**TO:** Cameron Mullins, Galloway and Company LLC  
**FROM:** Amber Wood Hicken, Planner I  
**DATE:** 9/16/24  
**SUBJECT:** Parker Pointe AMD1 L3A Car Wash – Site Plan Review Comments 01

PROPOSED CAR WASH FOR:  
**MISTER CAR WASH (CO 1452 STROH)**  
S PARKER RD • PARKER, CO 80134

**Project Number: SP24-086**

SHEET NUMBER  
E1.1

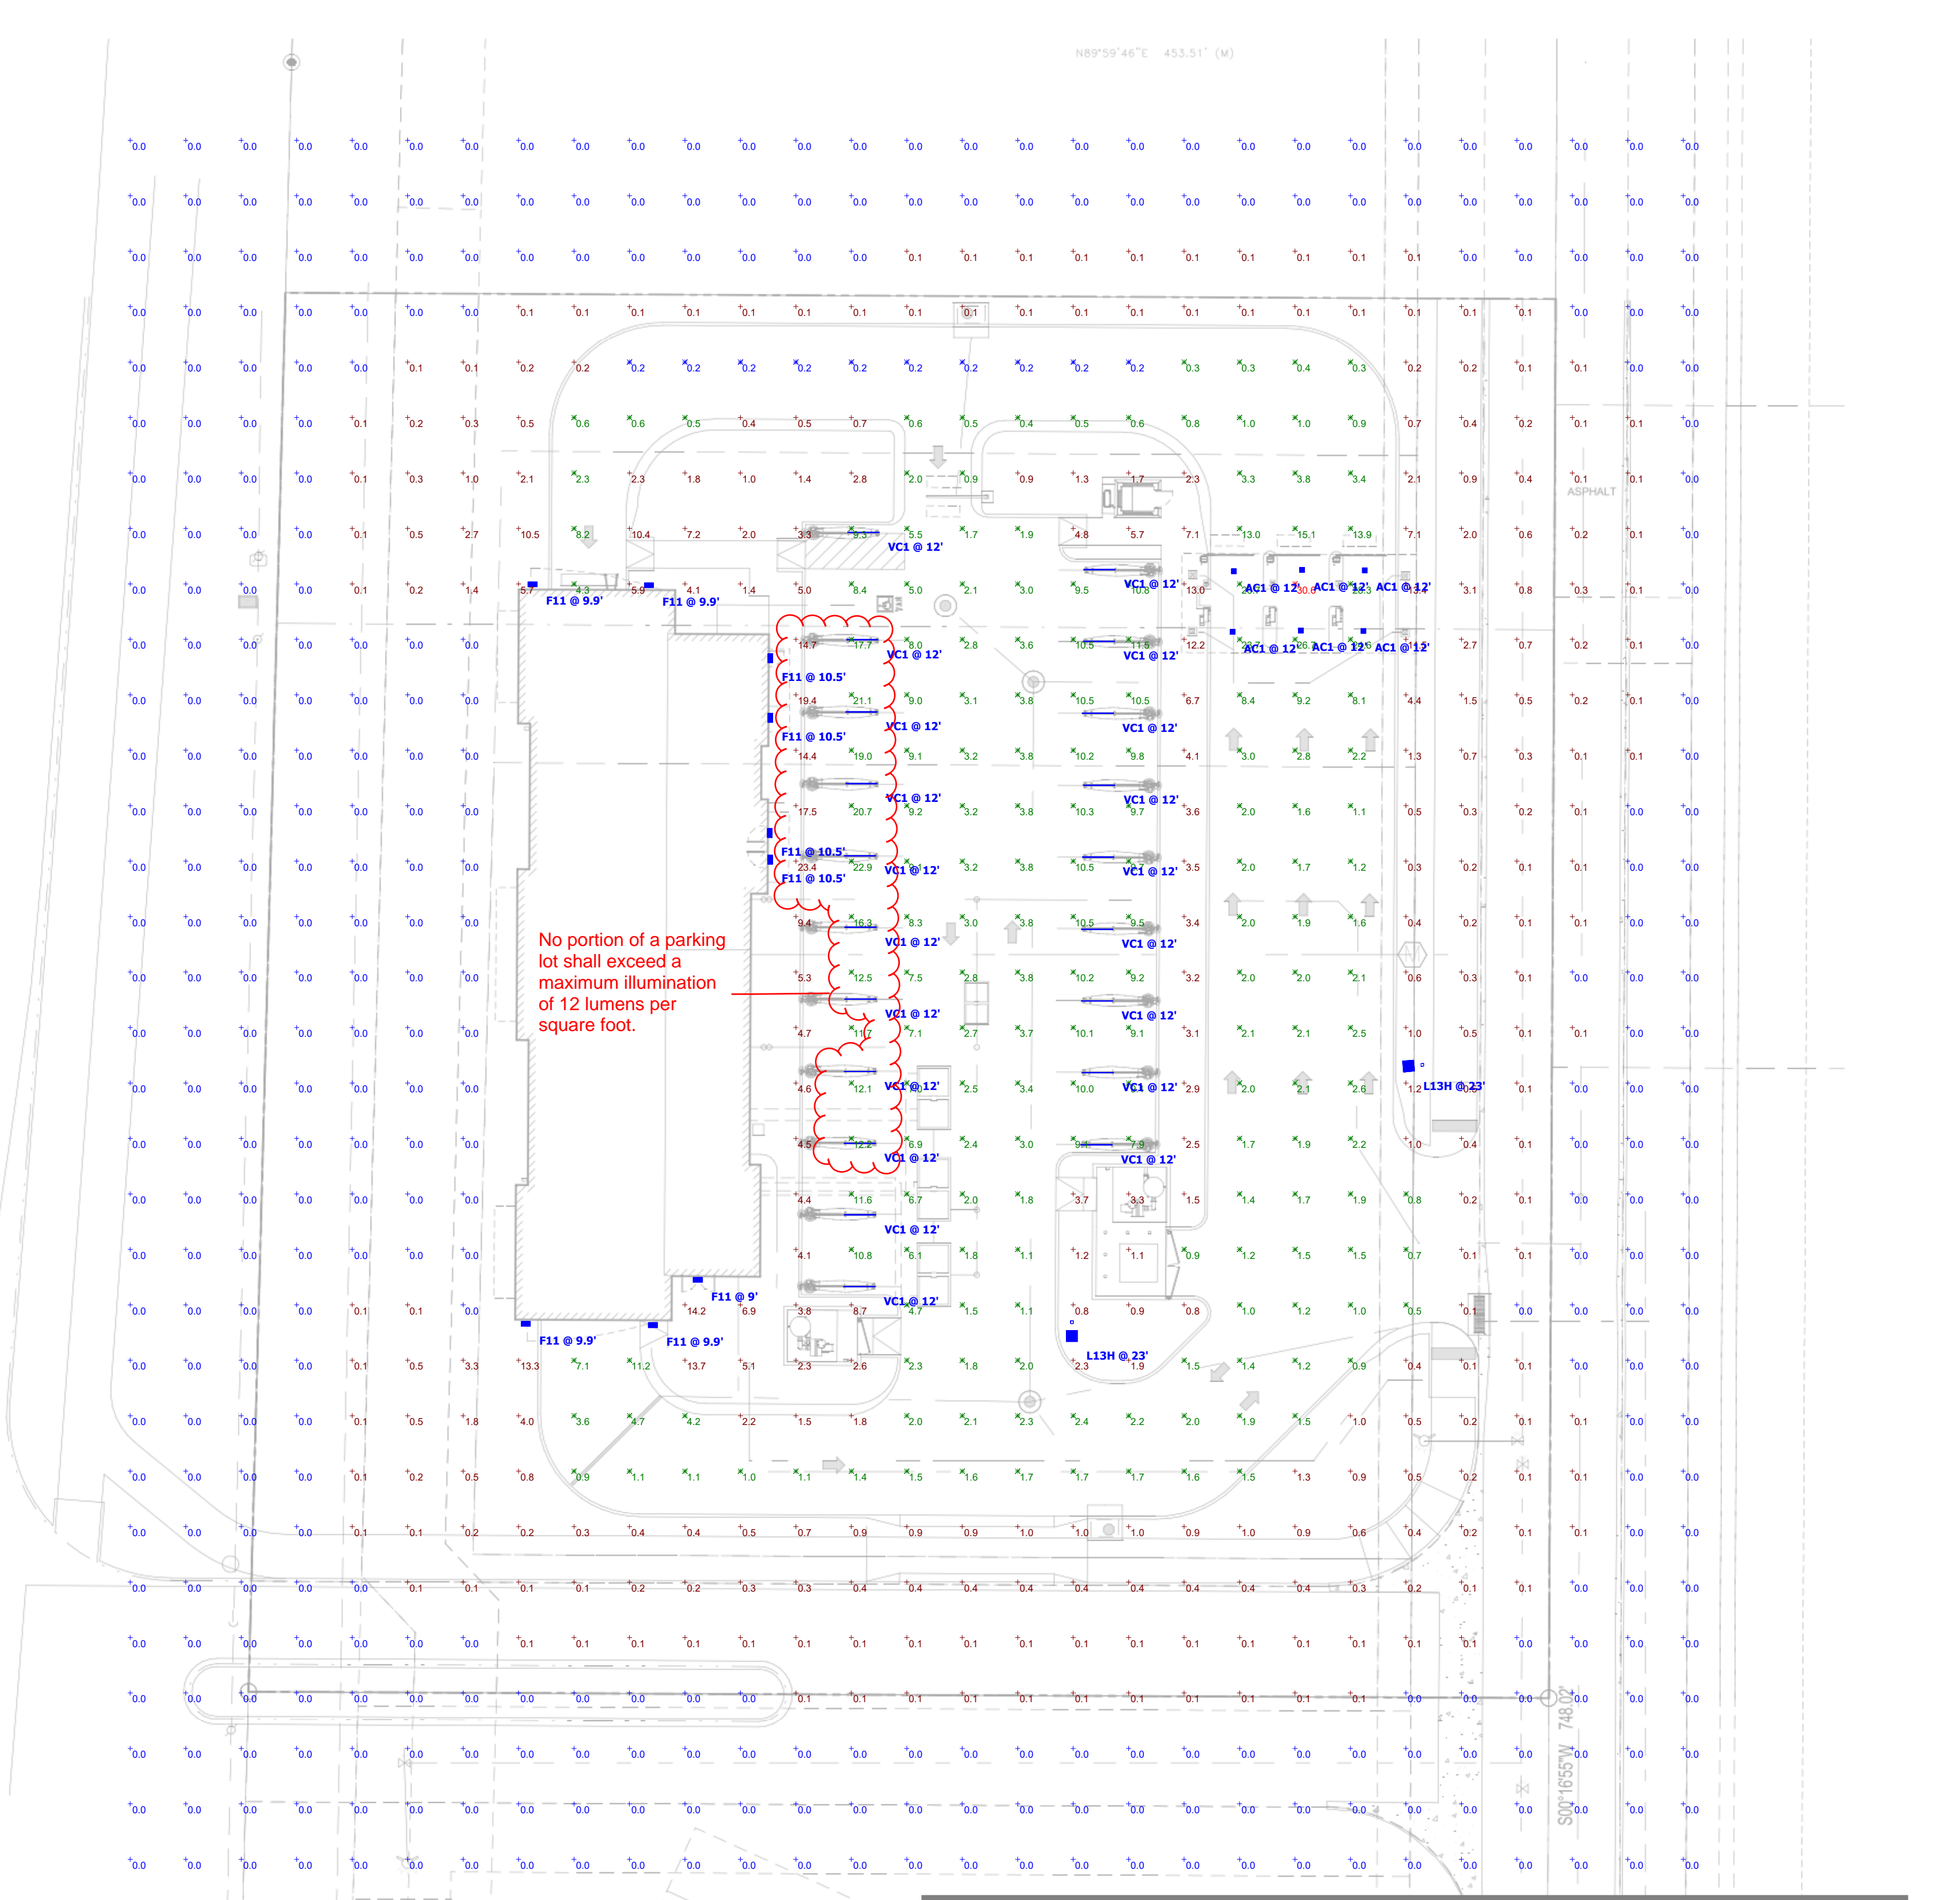
what are these zones? label as parking lot, etc.

**OFFICE ELEVATION**  
(NOT VISIBLE FROM S PARKER RD)

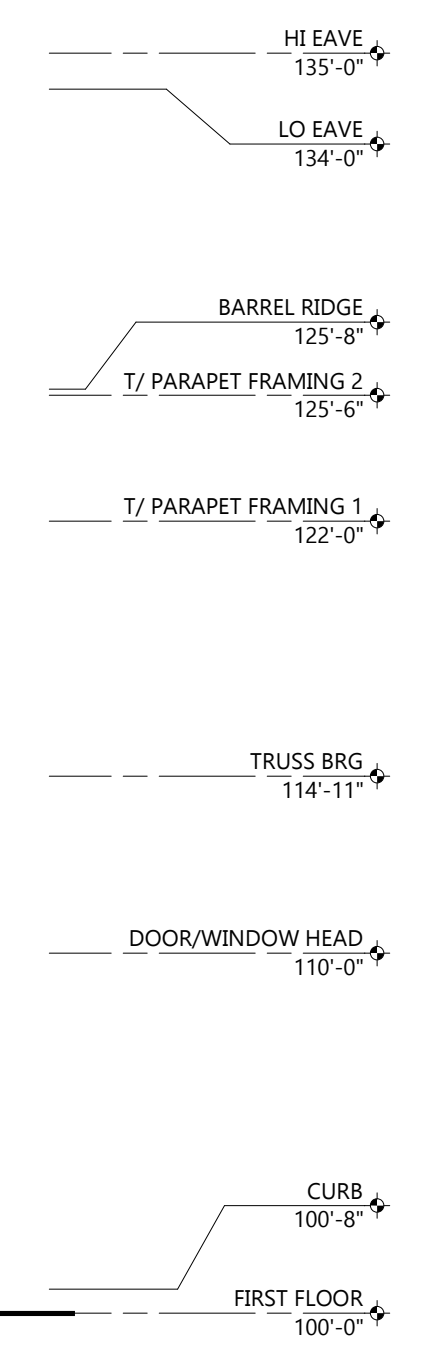
transparency requirements for east side?

**EXIT ELEVATION**  
SCALE: 3/16" = 1'-0"

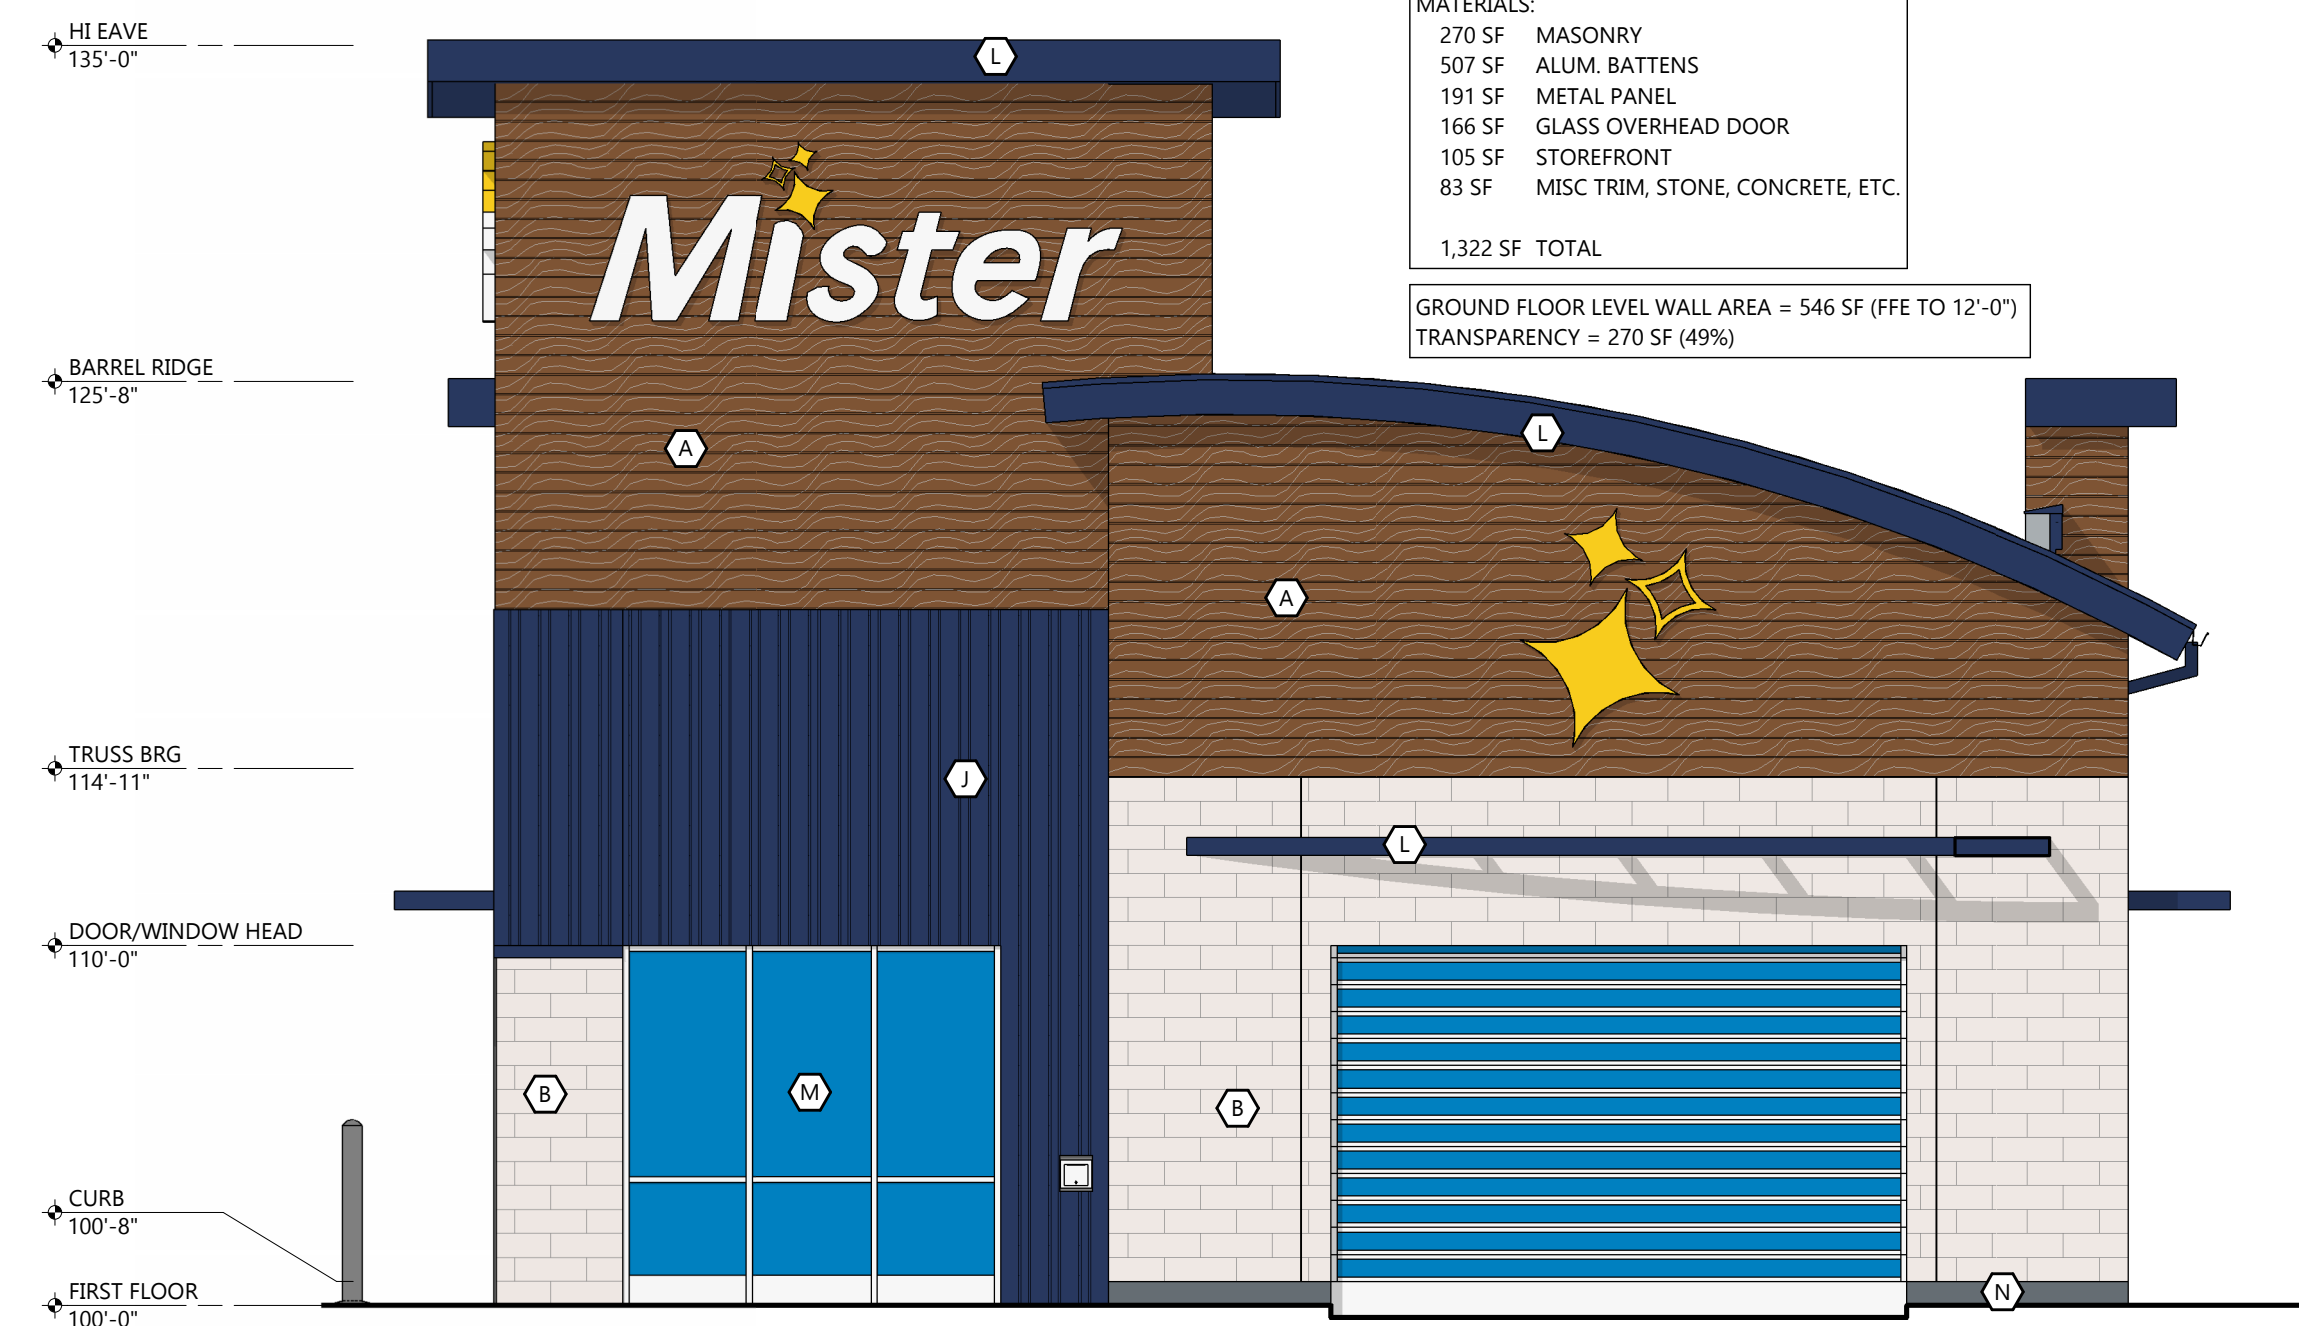
south facade is a building front - 40% transparency required

label with cardinal directions for all sides → **OFFICE ELEVATION**  
SCALE: 3/16" = 1'-0"

**TUNNEL ELEVATION**  
SCALE: 3/16" = 1'-0"

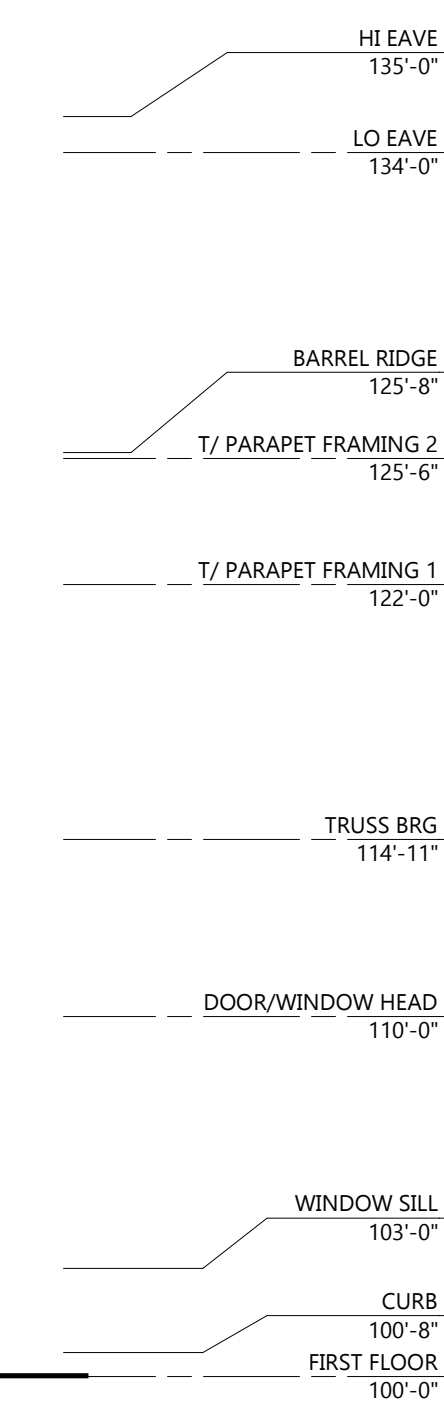
west facade is a building front - 40% transparency required
